WATER QUALITY DISTRICT

April 2, 2018

Re: Draft HHRA OU2 and OU3, BERA OU2 and OU3

(Montana DEQ Solid Waste Program Files – 1992 Inspection – note layering of ash/sludge)

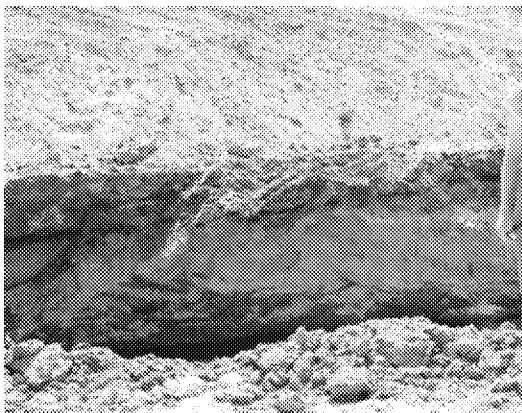
- As pointed out in previous comments, the mill bleached approximately 30% of its product in early years of production (see photo). This needs to be corrected in the site overview. Most subsurface samples were collected from 24- 30 inches. Deeper samples are needed to characterize older layers deposited when bleaching was at its peak and substances like PCBs were in common use.
